EN 1998-1:2004/AC

July 2009

Eurocode 8: Design of structures for earthquake resistance - Part 1:
General rules, seismic actions and rules for buildings.

Replace "Figure 5.1":

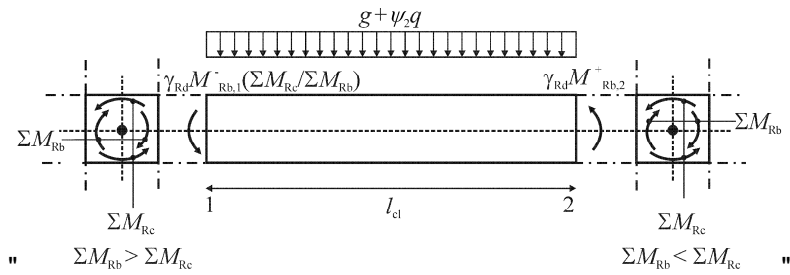
16) Modification to 5.4.2.2

" $\Sigma M_{Rb} > \Sigma M_{Rc}$ " $\Sigma M_{Rb} < \Sigma M_{Rc}$ "

with:
